ADDENDUM NO. 3

Jones National Bank Remodel and Addition
 Seward, NE
 TCEP No.: 721-003-12

Addendum 003
 Supplemental Drawing: SDA 001
 Revision of Sheet: A8.04
 Date: 03/15/13

9 SECTION - South Stair
 SCALE: 1/4" = 1'-0"

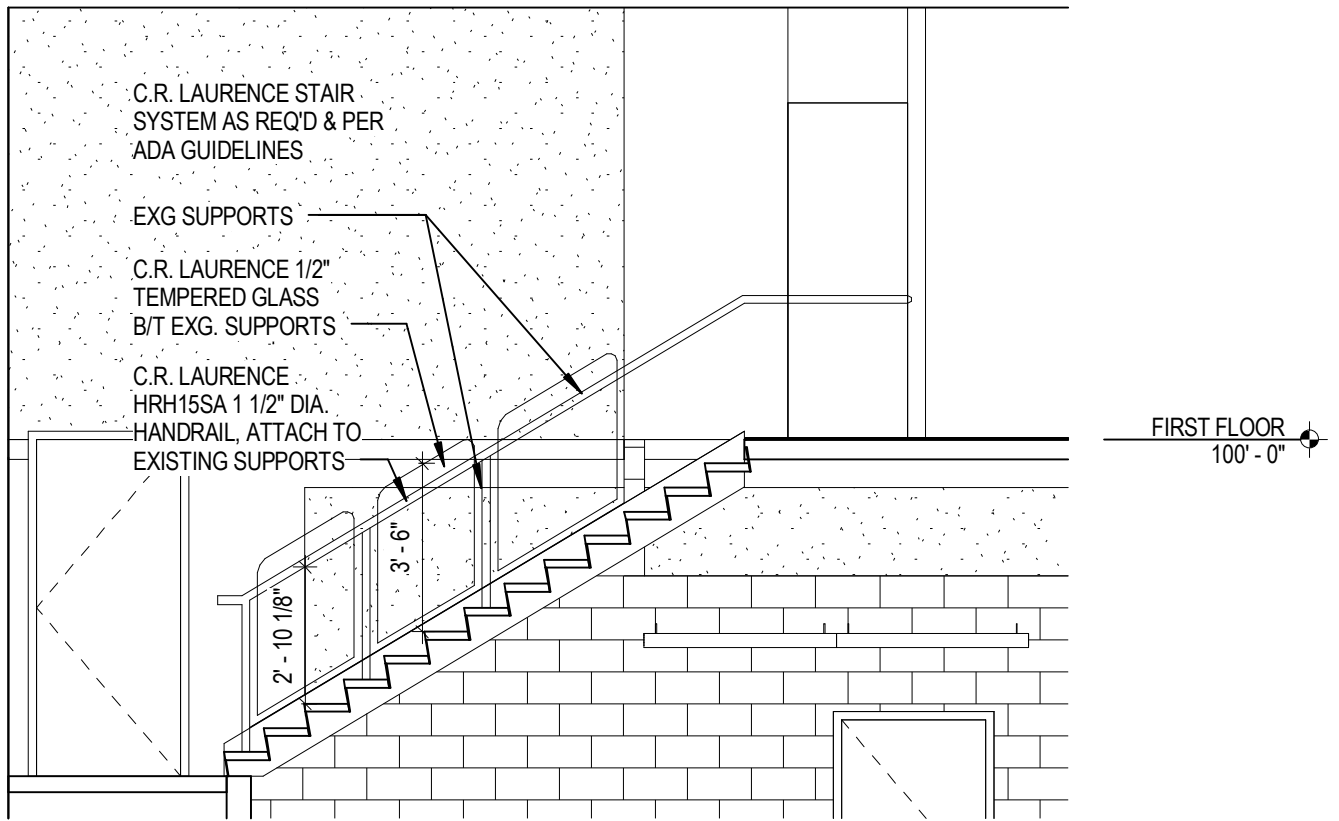
Item 3-8: Sheet A8.04 – Section Details

Refer to Supplemental Drawing SDA-001 for revisions to Detail 9.
